**Applicant Response to DAPRS –
2 February 2022**

**RE: D/2020/993 Response to Design Advisory Panel Residential Subcommittee advice sheet 21/2021
422-424 Cleveland Street, Surry Hills**

3D – Structural Schematic Diagram of buildability of Level 4 over existing building roof

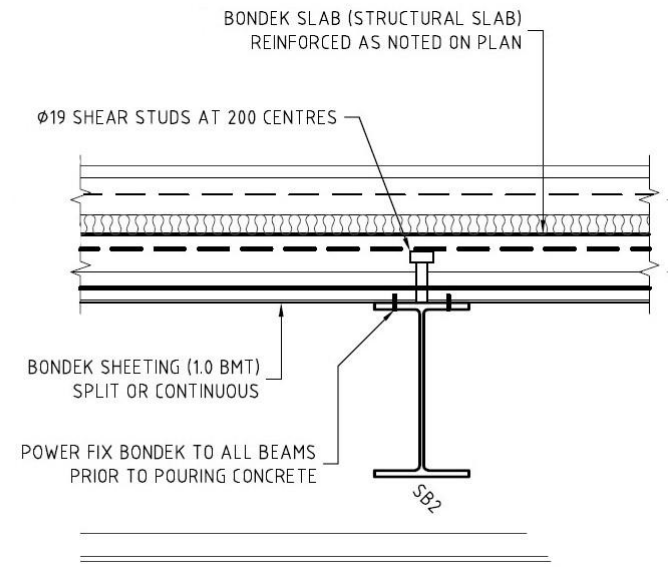
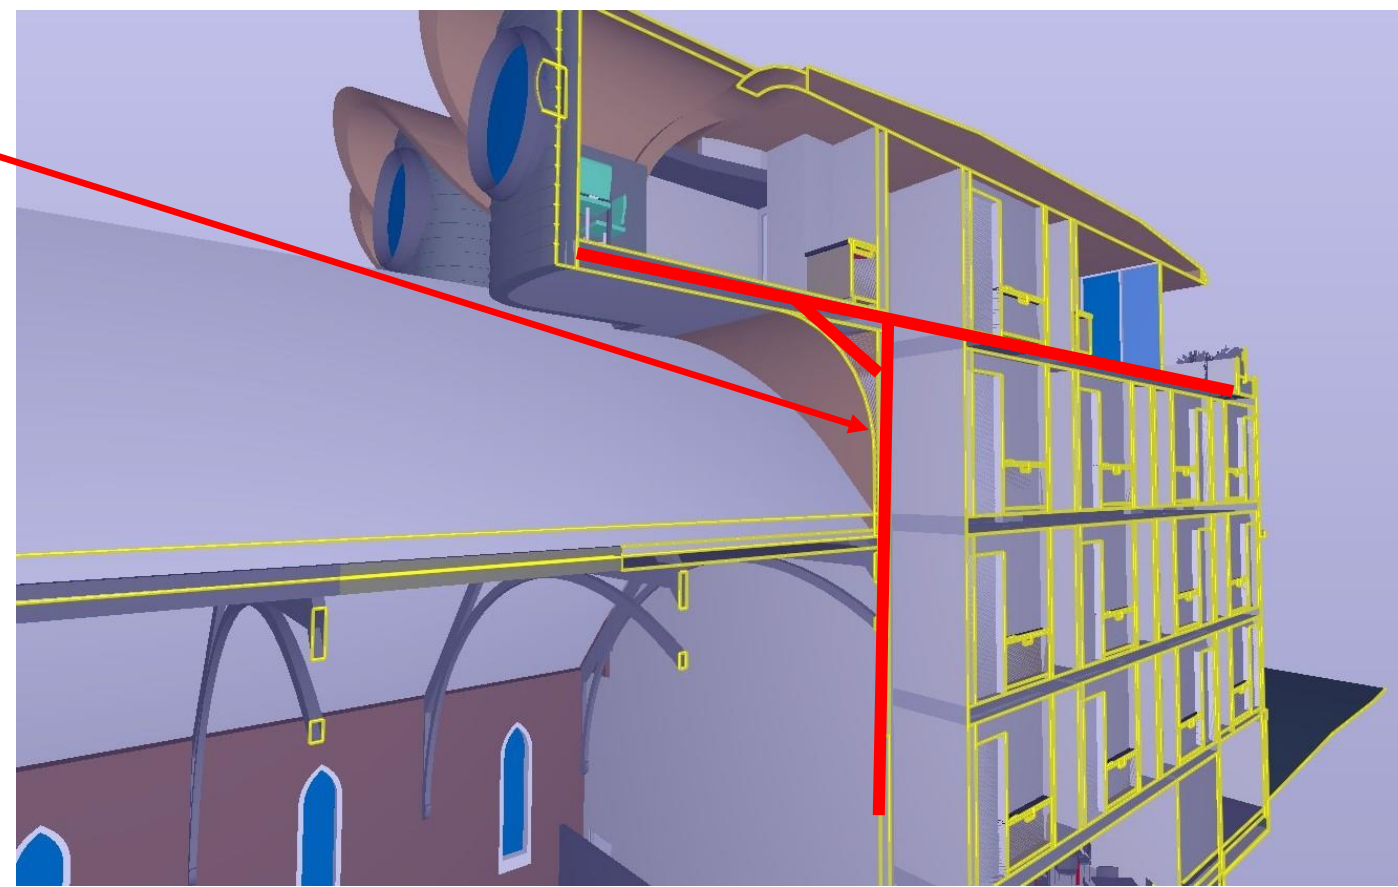
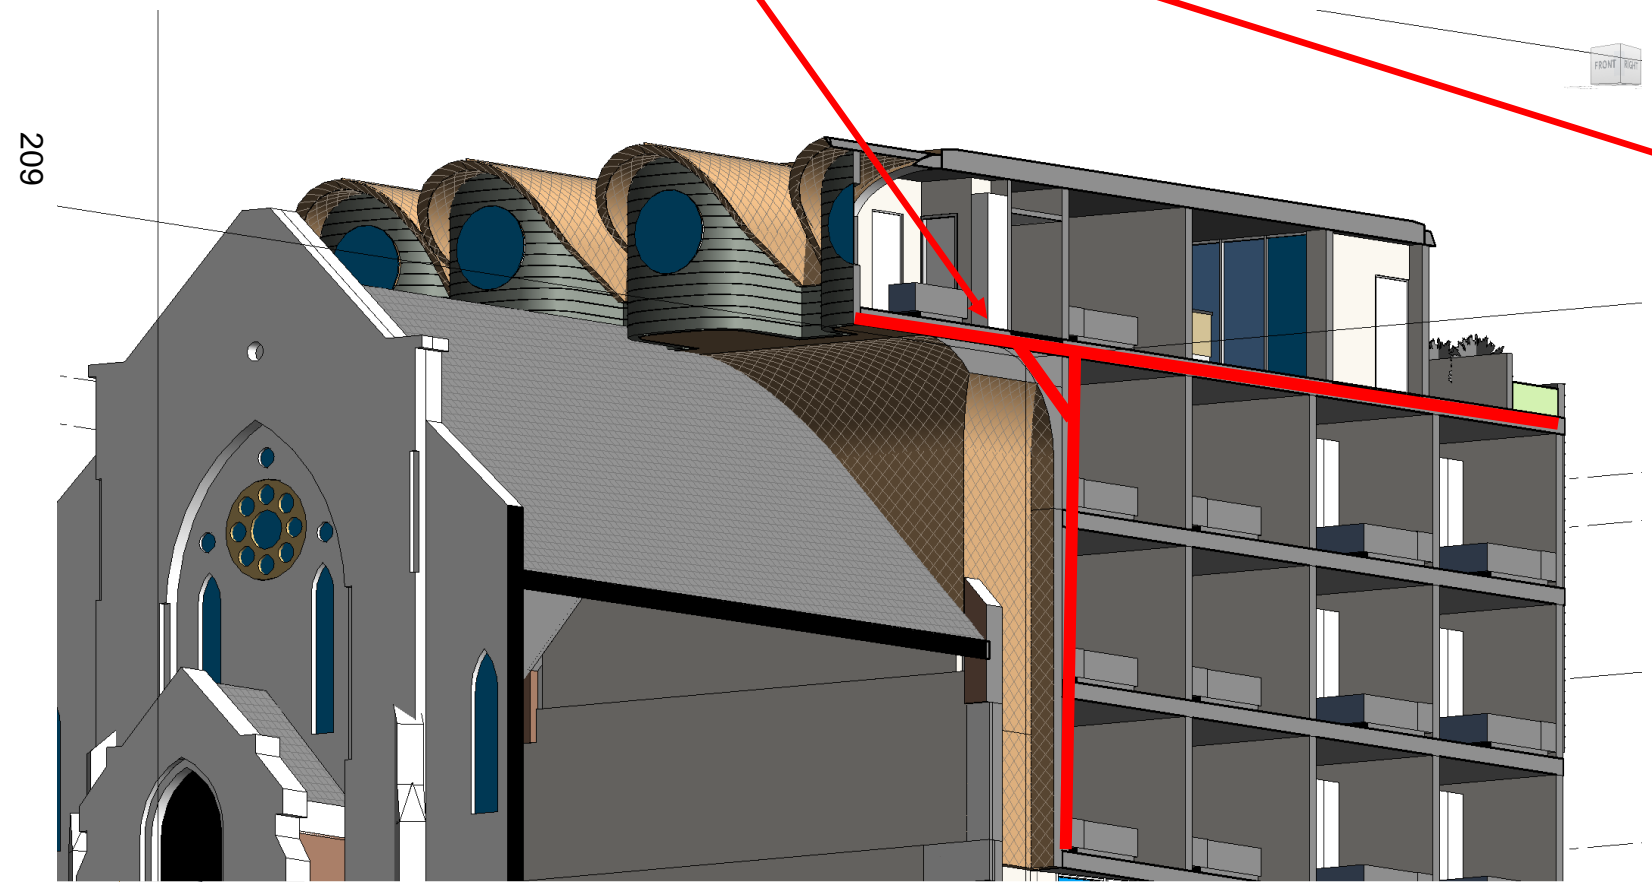
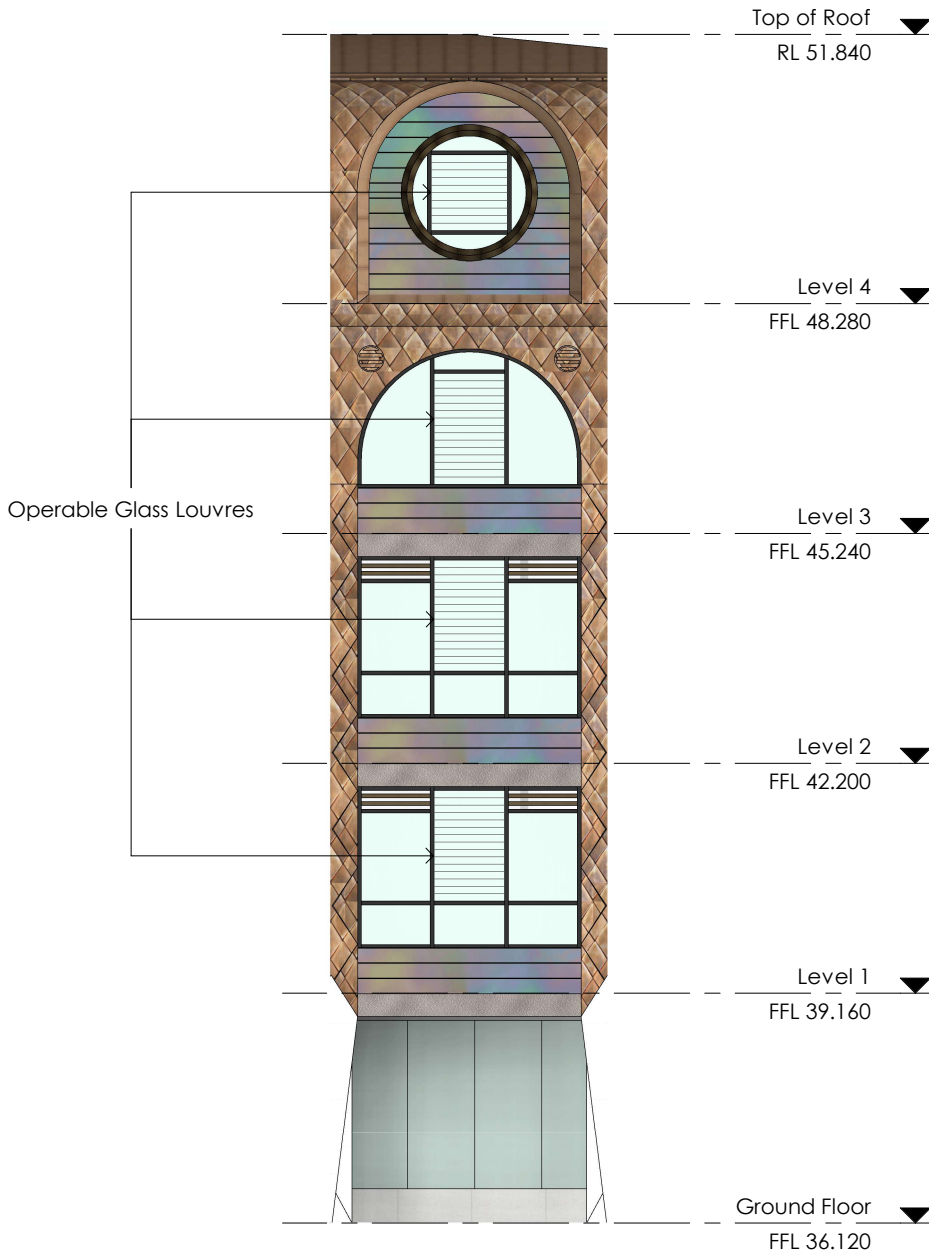
#	DAPRS Matter	Response
9	<p>The relationship between new additions and existing structure has improved with the retention of all timber support arches, the deletion of new columns through the space and a reduced basement area, however, still needs further resolution (refer Section D on DA 5.02). The overhang remains excessive creating a poor relationship with the heritage item. The overlap of the church ridge and the cantilever needs structural clarification. The scale of the overhang could be further reduced without a reduction in room numbers. The geometric and material resolution of the underside of the overhang may benefit from further modelling studies.</p>	<p>We highlight that this advice has been formed with reference to the Kirk being a heritage item. The existing church building is <u>not</u> a heritage item. It is a contributory building within the heritage conservation area.</p> <p>A further reduction in the cantilever element would result in a loss of amenity to the artist-in-residence rooms which are a core component of the housing diversity offered on site. The submitted visuals have demonstrated that this portion of the proposal is not readily perceived from the surrounding public realm, and it follows that there would be no visual benefit from additional setback.</p> <p>Clarification on the structural solution for the cantilever prepared by a structural engineers SDA Structures was submitted to council on 3 December 2021, prior to DAPRS, although we are not aware if DAPRS have reviewed it (re-submitted with this correspondence at Attachment A). The applicant is happy to accept a condition of consent requiring detailed structural drawings prior to the issue of a construction certificate.</p>

Bondek metal sheet formed concrete slab floor which can be unpropped over the church building and does not require formwork or temporary support over church. Concrete is placed safely using strut and beam system for temporary stability and composite construction in the final completed structure. Fire protection to entire floor to be provided via intumescent paint if steel scheme selected.

1 East Elevation - Typical Window Operation Levels 1-4
1 : 100

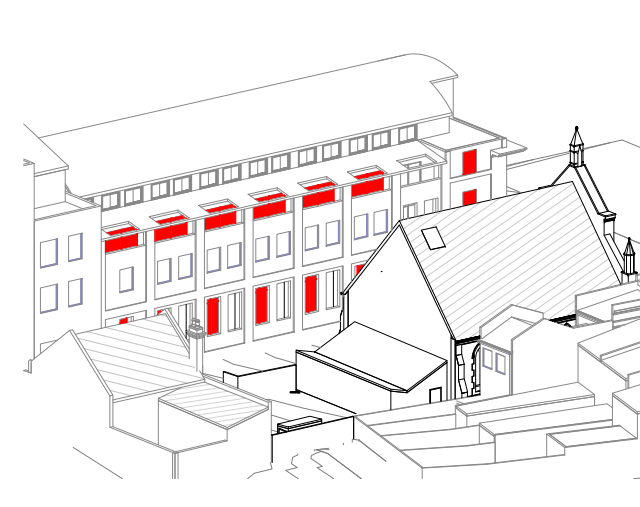
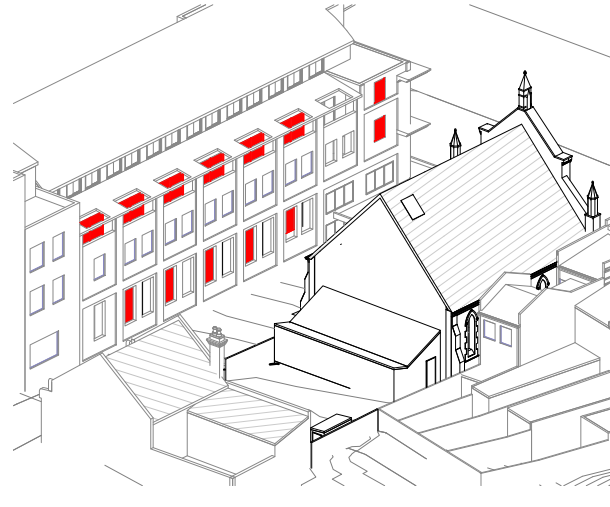
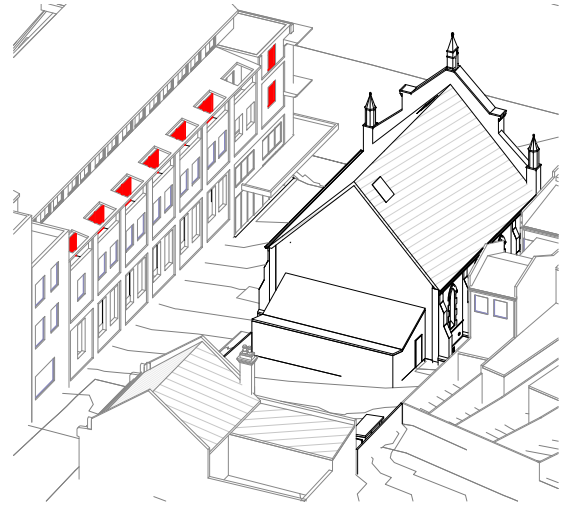
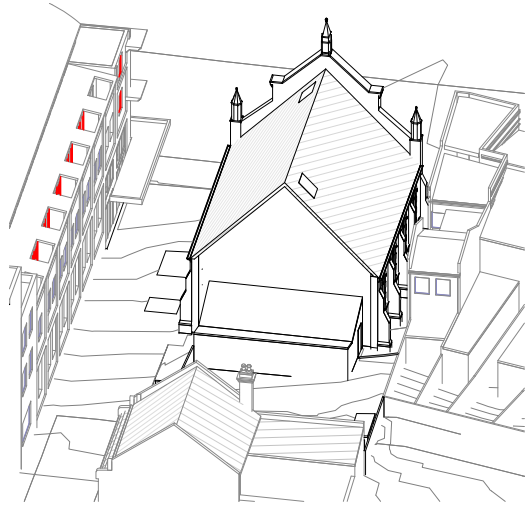
12	Window operation should be indicated on the elevations.	The opening parts of the windows will be louvres. An A4 sketch SK9.50 is provided for a typical set of windows indicating the opening portions and fixed panels (Attachment B).
13	The area of communal living may not be sufficient for the number of people served.	The ARH SEPP does not mandate a minimum common room size. It should be noted that the development will be operated as a joint venture between 107 projects and UKO co-living, in a manner that allows residents to benefit from access to the basement workshop and the community hall (when not in use for events). Both of these spaces contribute to the availability of common indoor space.
14	Private outdoor space needs to be provided to 30% of the rooms.	The private open space requirements of Division 3, (29)(2)(d) of the ARH SEPP have been met. The ARH SEPP sets out that a consent authority cannot refuse consent for a development on the grounds of private open space if the requirements of this clause have been met.

Title
Views from the Sun
Comparison of Massing Envelopes
21 June

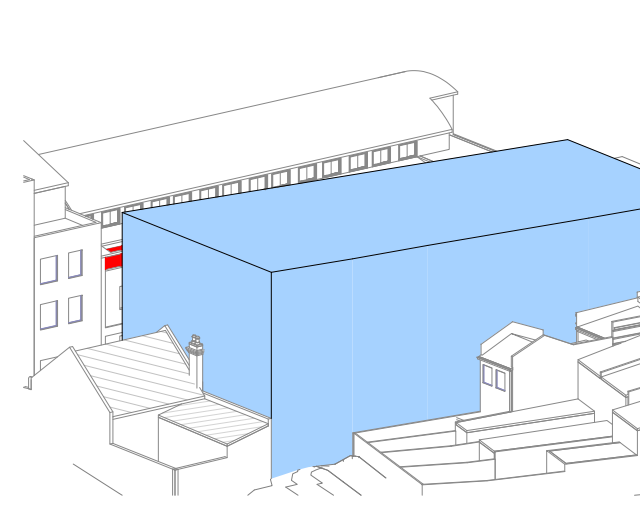
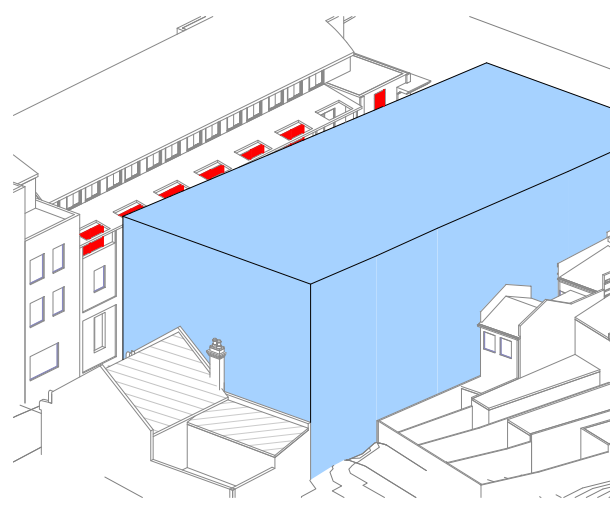
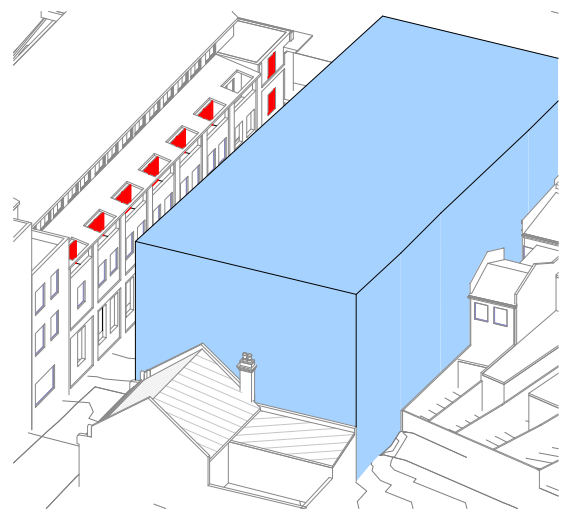
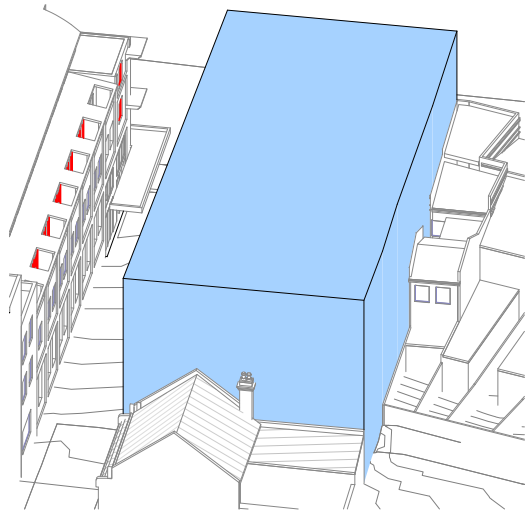
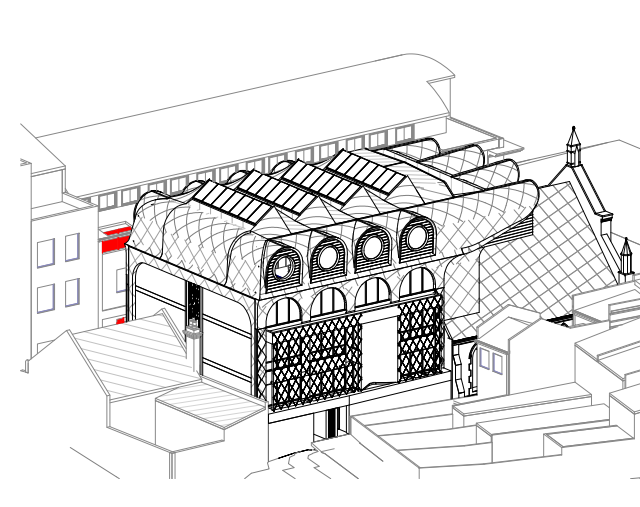
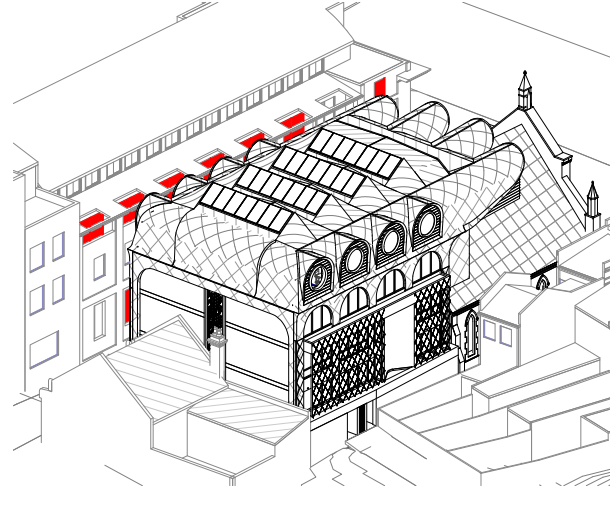
#	DAPRS Matter	Response
1	The Panel appreciates the applicant's aspiration to provide a cultural entertainment venue and the desire to for the commercial aspects of the development to contribute to viability. The proposed changes to the design have increased the retention of heritage fabric which is supported by the Panel.	Noted. Support from DAPRS is welcomed.
2	The reduced height and overall scale of the additions can now be considered acceptable, however, any impacts on neighbours due to additional shadowing need to be clarified. Although there is a distinct jump in building height from High Holborn Street and Goodlet Lane to development controls along Cleveland Street the proposal has improved to include landscape and terrace to step down in scale on the north of the upper level.	<p>The submitted drawing set includes an overshadowing analysis that clearly demonstrates the impact on neighbouring properties. The analysis has been subject of ongoing discussion with council and demonstrates that the reduction in height of the building will not serve to reduce overshadowing.</p> <p>View from the sun diagrams were previously provided to Council in March 2021, for midday onwards on 21 June. Prior to midday there is no overshadowing impact beyond that which is existing shadowing. The analysis demonstrates that:</p> <ul style="list-style-type: none"> • 426 Cleveland Street existing west facing living areas with 2 hours sunlight = 8. • Where a 15m envelope on the Kirk is project, west facing units with 2 hours sun = 6 • DA as submitted, west facing units with 2 hours sun = 7 • DA as amended through assessment period, west facing units with 2 hours sun = 8. <p>The analysis demonstrates no net reduction in units achieving 2 hours sunlight. Further, that an additional setback to the east boundary achieves little in the way of reducing overshadowing, however the cutback to the north boundary, introduced in the DA assessment period, has reduced overall overshadowing.</p> <p>The officer recommendation for approval at LPP on 3 November 2021 found the overshadowing impacts to be acceptable on the basis of this analysis.</p>

426 Cleveland Street west-facing living areas with 2 hours sun = 8 (57% of west-facing)

426 Cleveland Street west-facing living areas with 2 hours sun = 6 (43% of west-facing)
